The 55 details drawn differently in CAD and Revit

Checked against the new drafters' file, 26 October.

55 of the 190 CAD typical details have a Revit version in your templates that is drawn differently. Each page: your CAD detail on the left, the Revit version on the right, what differs, and one answer: CAD is right, Revit is newer (we update CAD from it), or both wrong.

CAD: KOR-D302-DET 08 - BASEMENT WALL SECTION

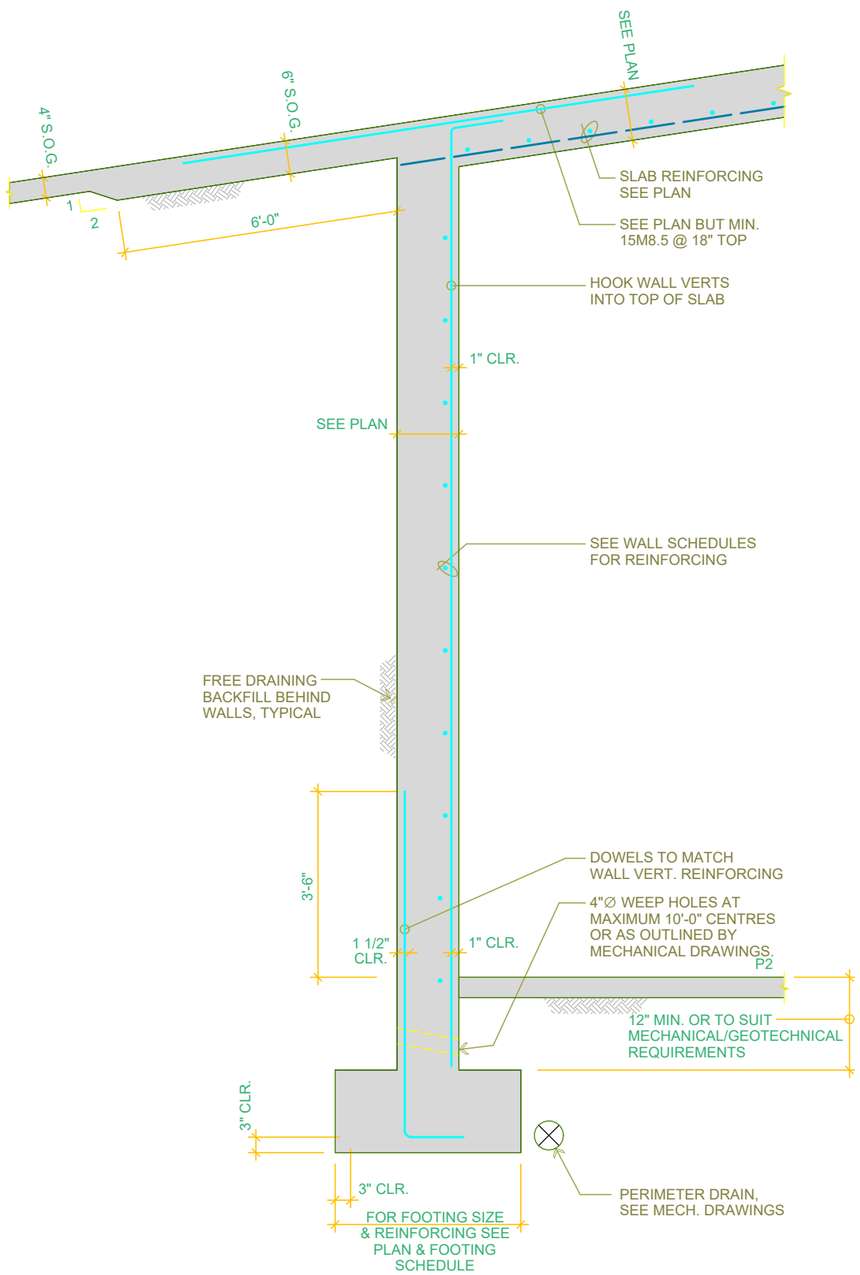
What differs: Wall with sloped slab over as 'S5.05_1_BASEMENT WALL DETAIL' but ending in a stepped raft rather than a strip footing.

CAD: KOR-D401-DET 04 - STEP SECTION

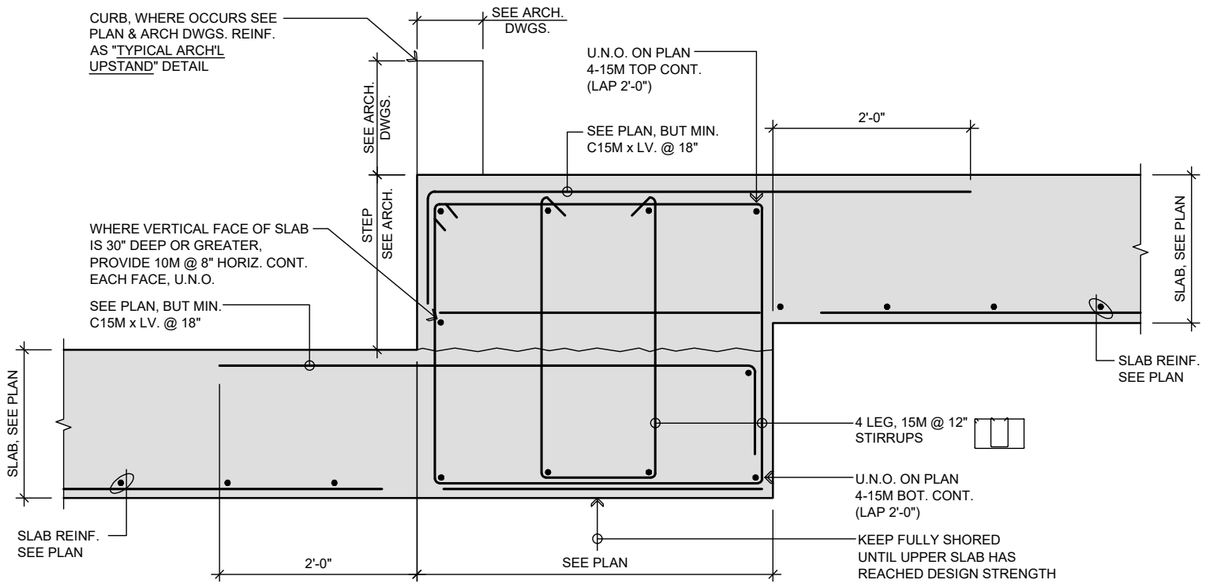
What differs: Top step built as a second pour with 10M grid dowel plus soffit step; 'D4.01_1_STEP SECTION' is a stirruped slab band step - closest only by purpose.

Revit: D5.01_4_RAMP DETAIL (Typical Details - Container_R23 (Need_MET & IMP).rvt; on D5.01 Series 5 Miscellan)

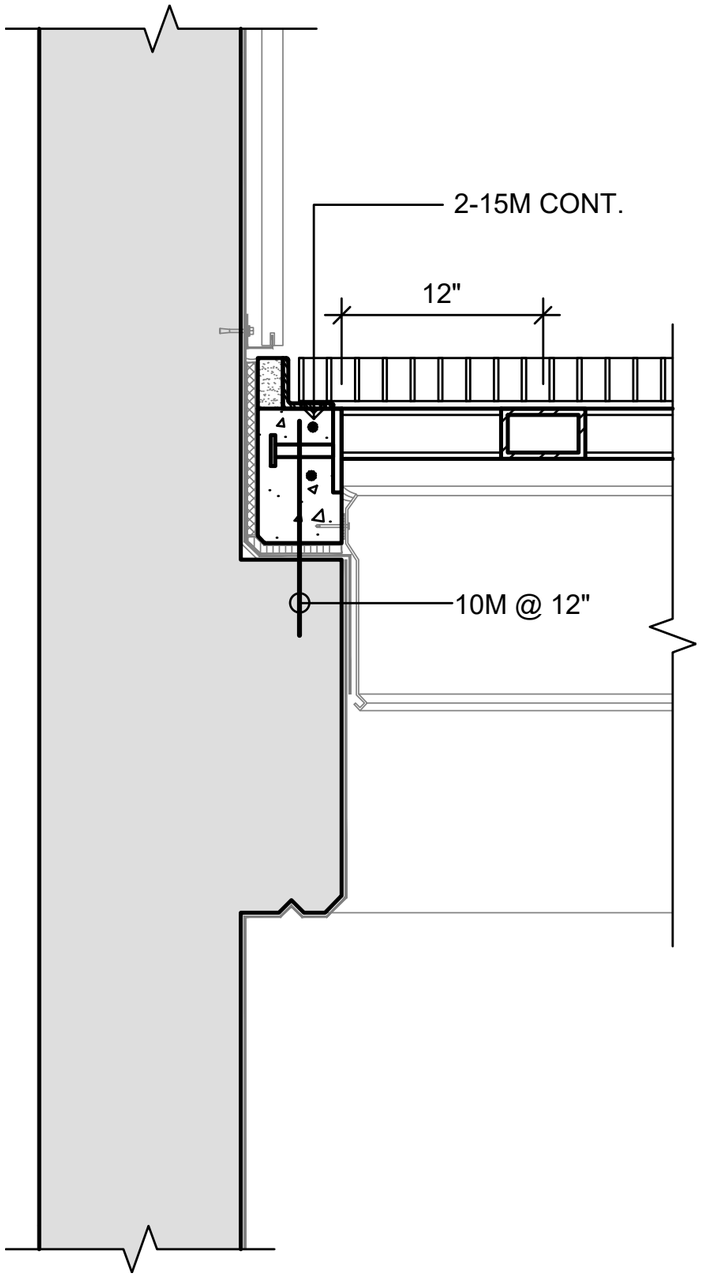
What differs: Ramp rising into slab band without 'D5.01_4_RAMP DETAIL"s cranked second set of top bars.

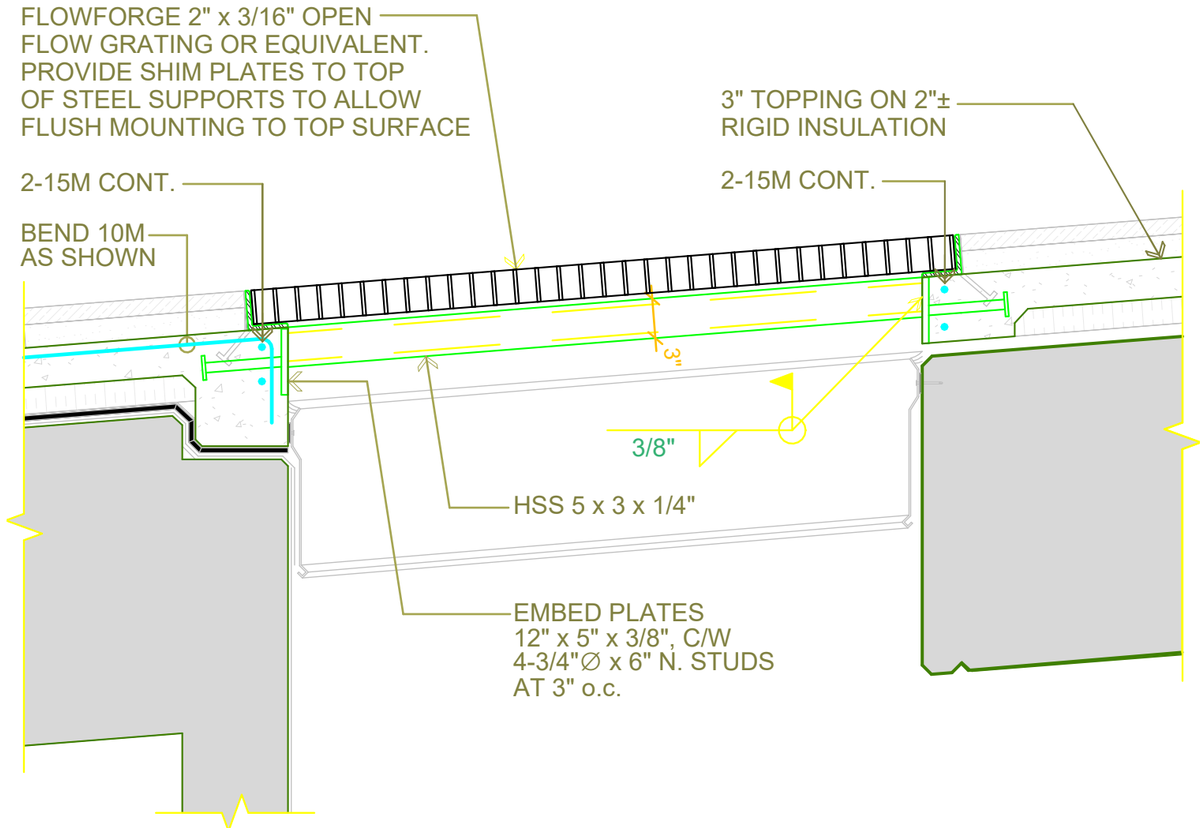
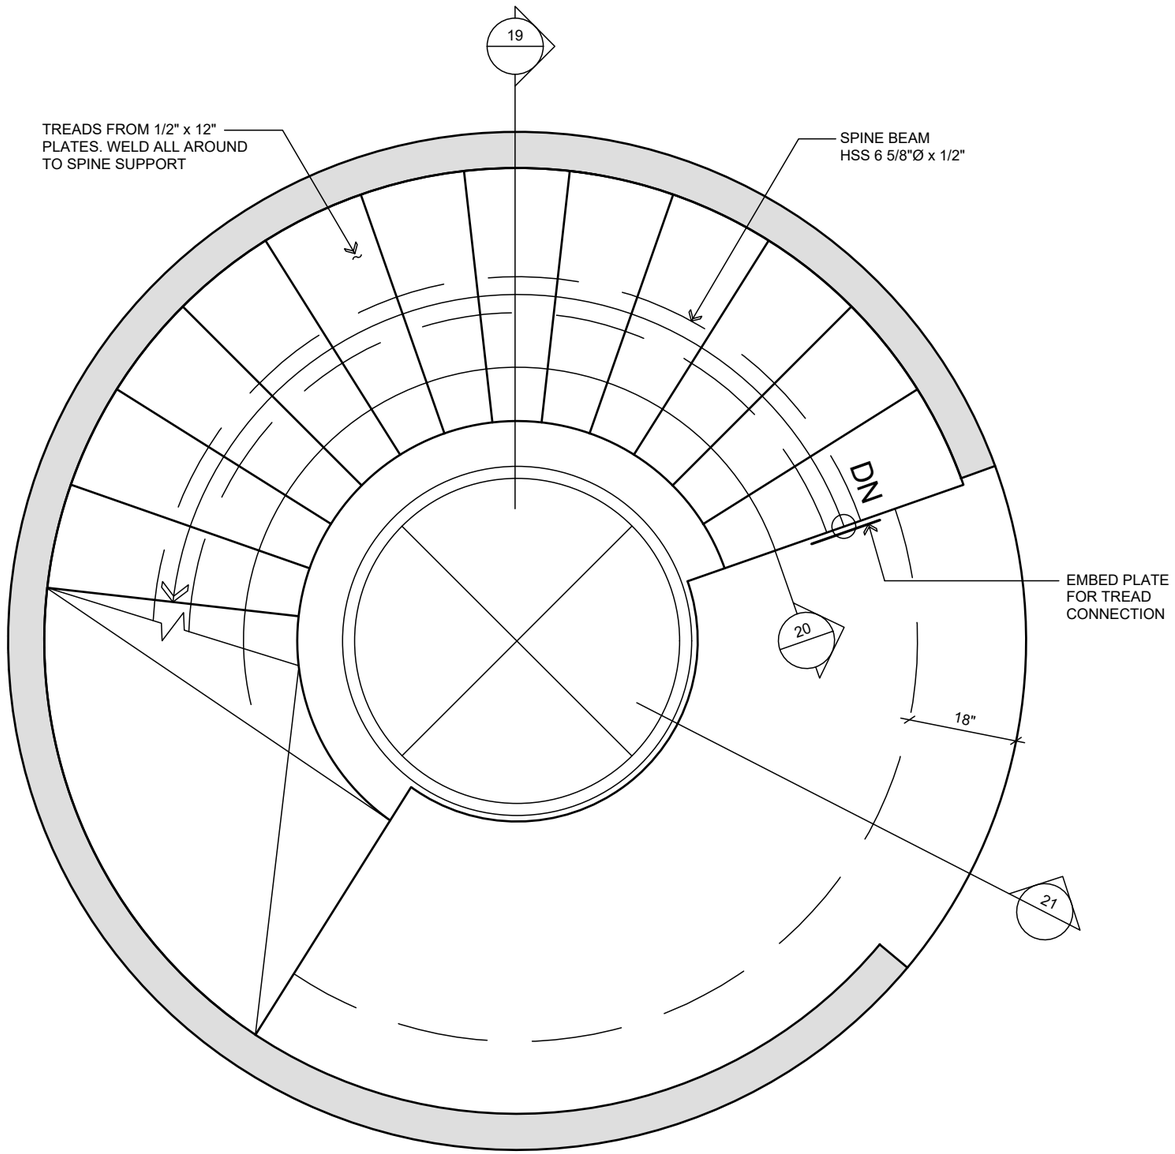
What differs: CAD is the grating support at a wall face with ledger and 10M dowels; 'D5.01_13_LOAD BEARING STEEL GRATING SECTION' is the grating spanning between slab edges.

CAD: KOR-D501-DET 18 - PENTHOUSE SPIRAL STEEL STAIR PLAN

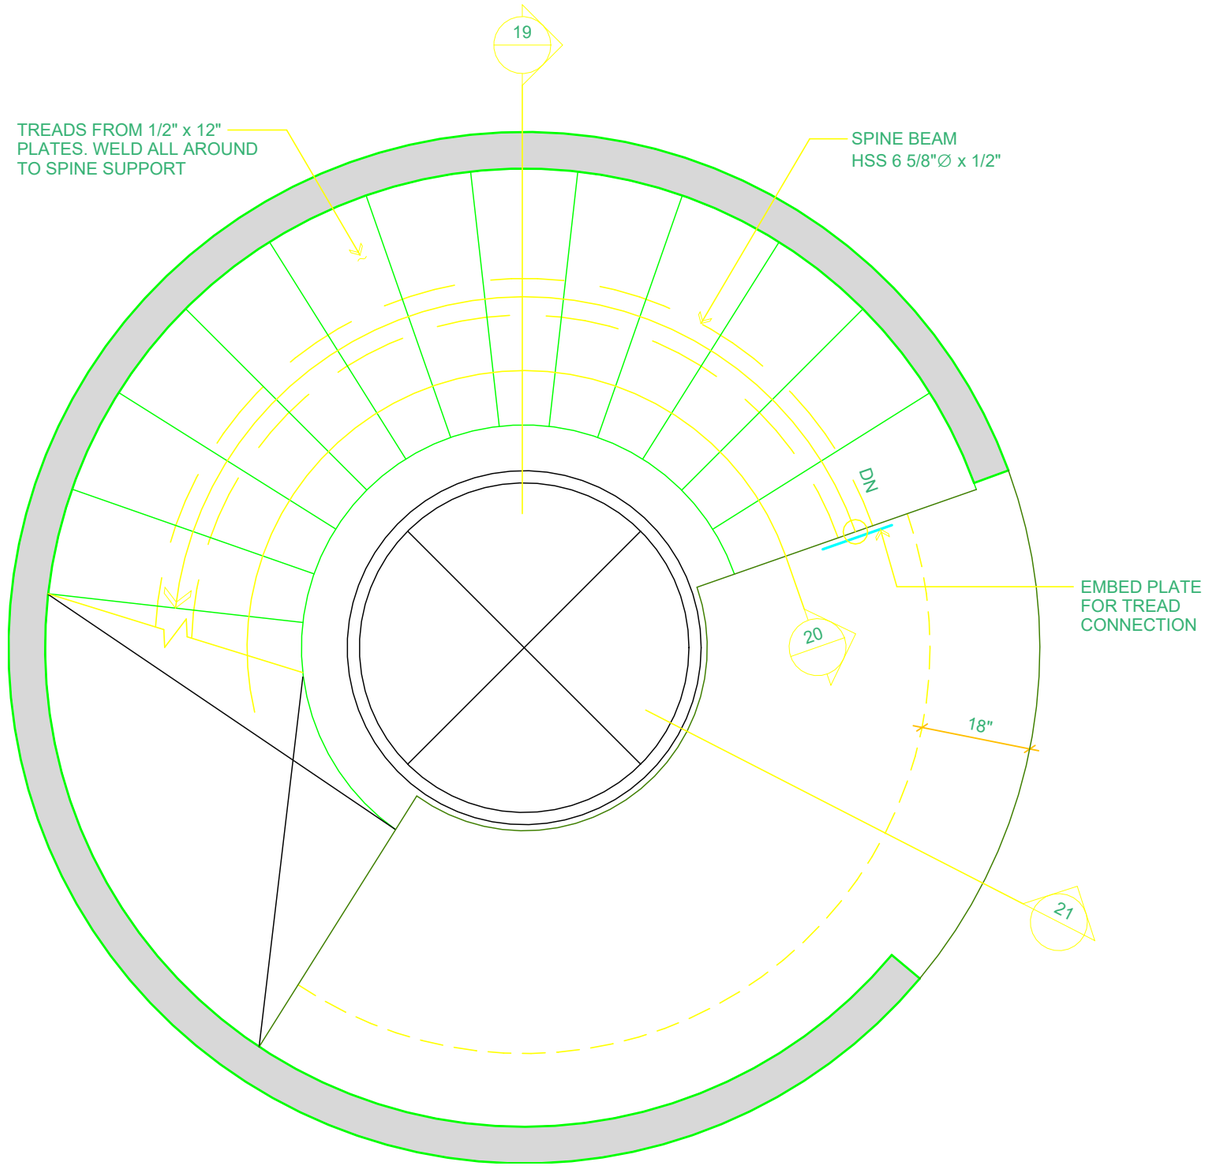
What differs: Same spiral stair plan content (treads, spine beam, embed plates) but CAD plan is drawn elliptical, Revit circular.

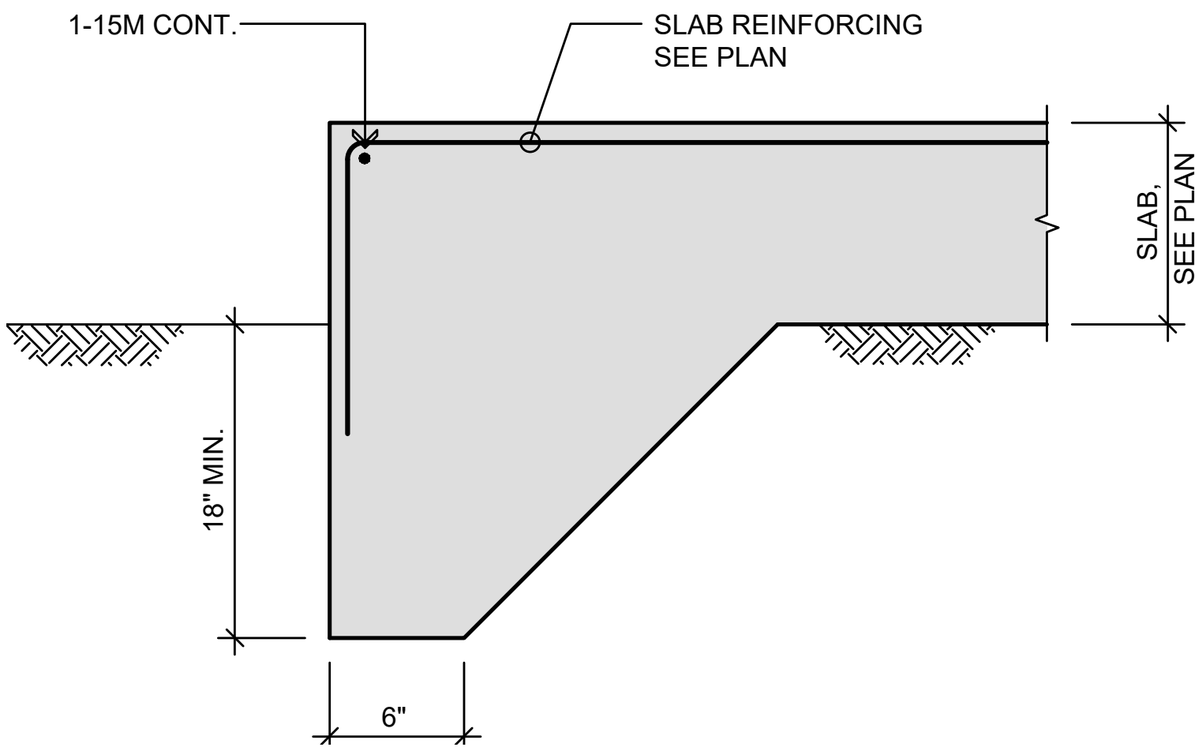
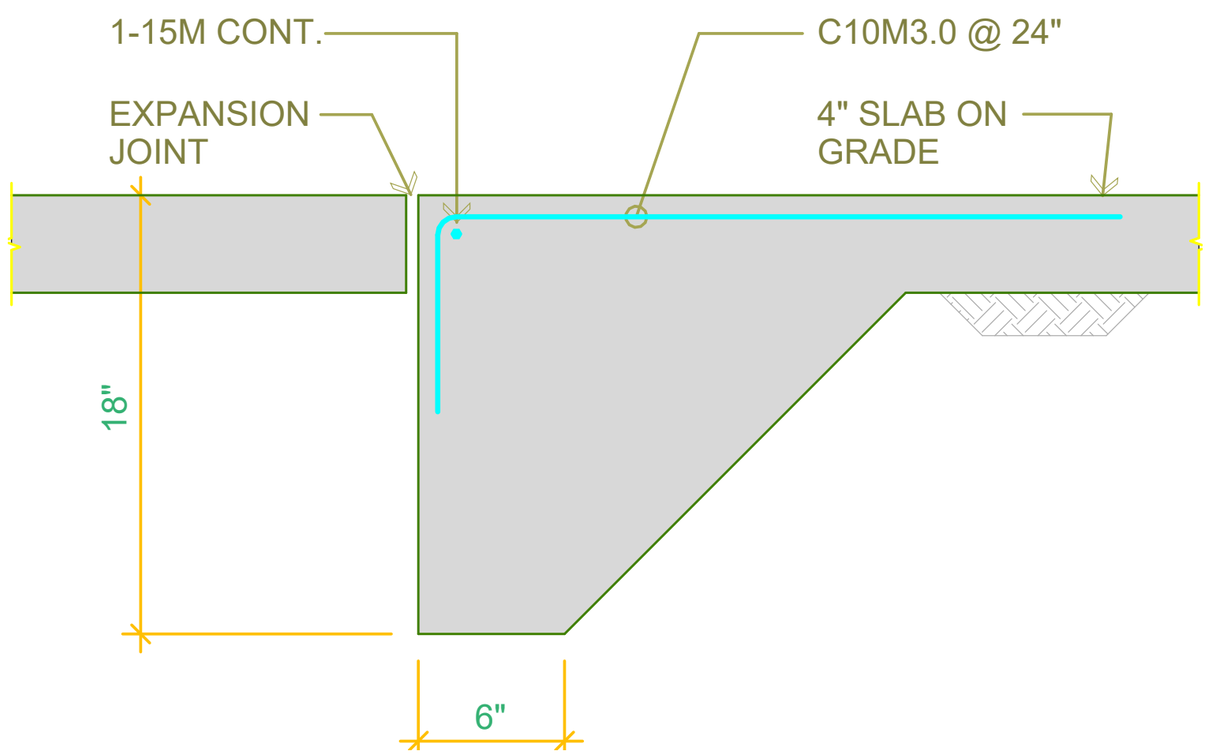
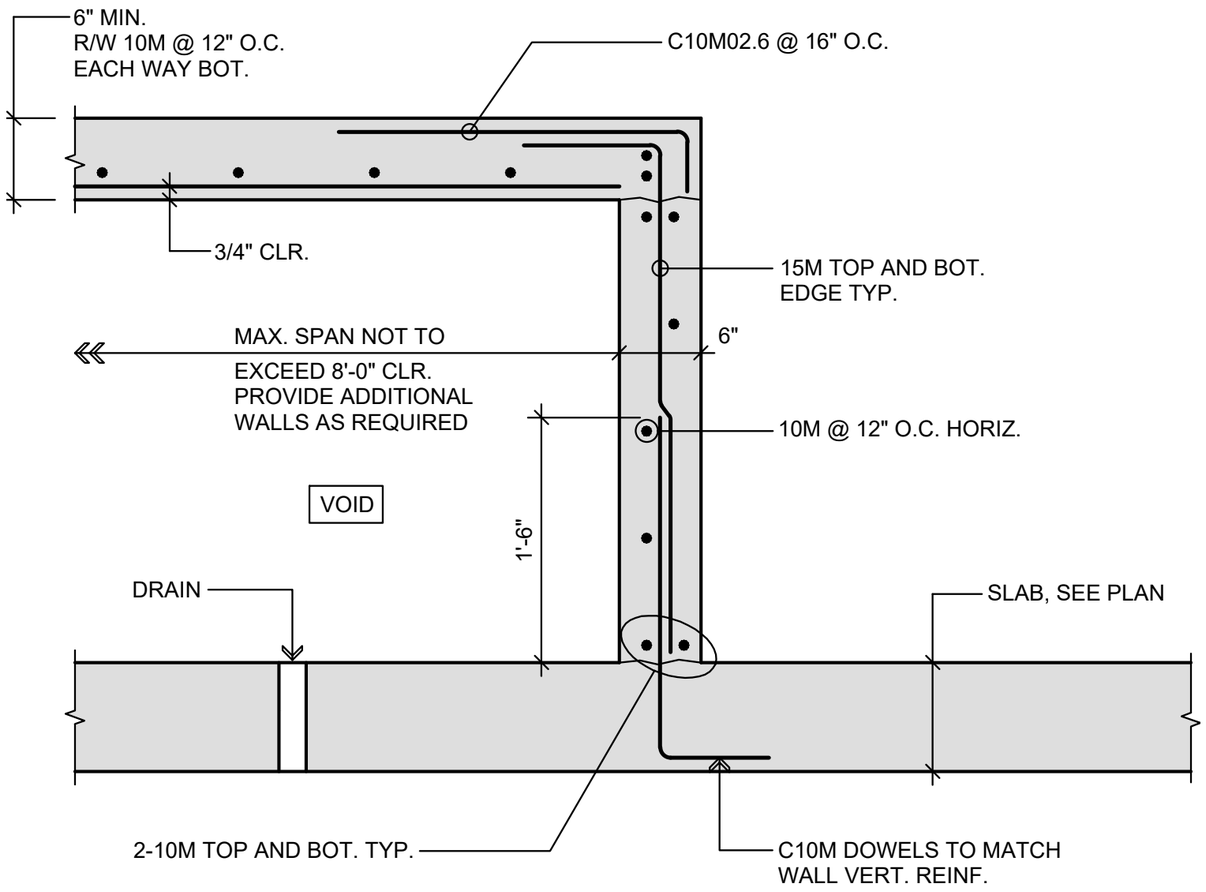
What differs: Thickened slab edge like 'D5.02_10_TYPICAL ON GRADE SLAB THICKENING' but no expansion joint/adjacent slab and different callouts.

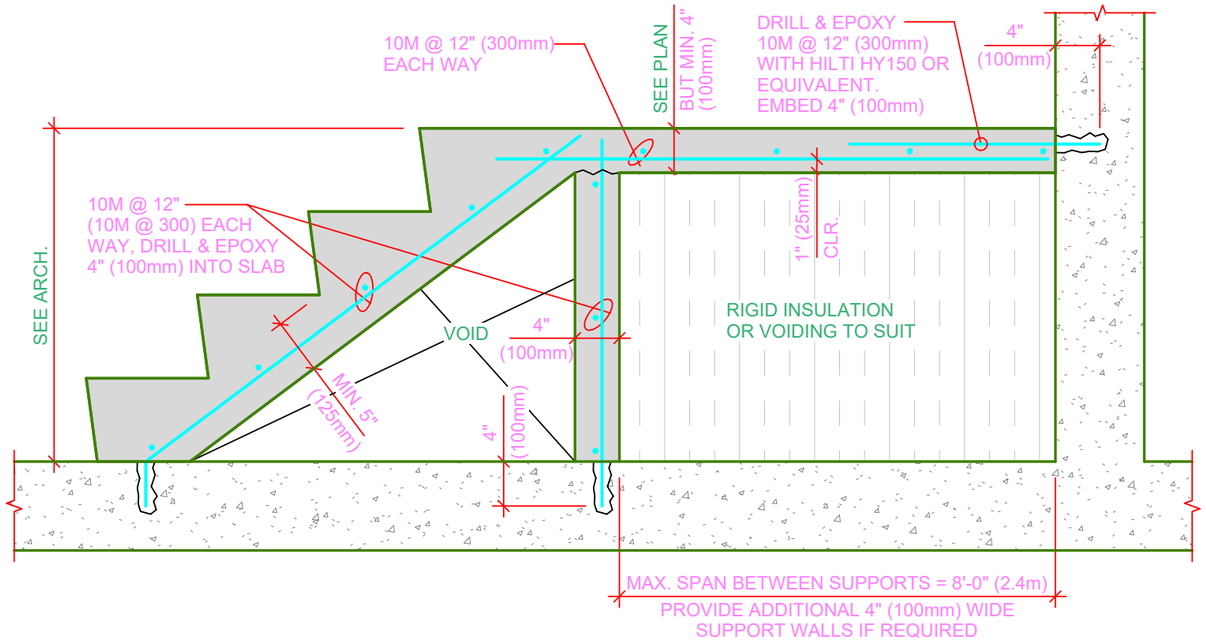
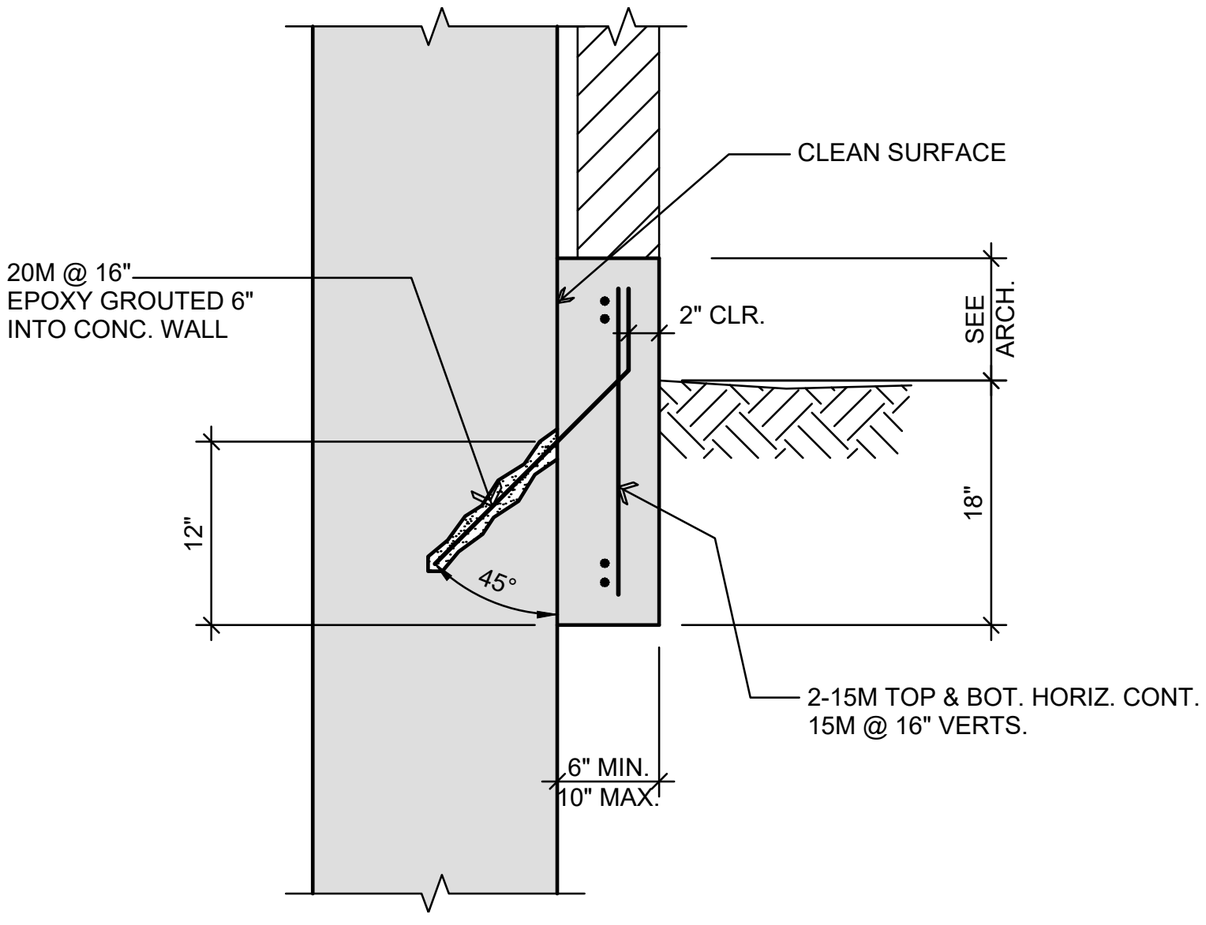
What differs: Both built-up slabs with void and max 8ft span support walls, but CAD is slab on walls with drain, Revit is stepped fill with insulation.
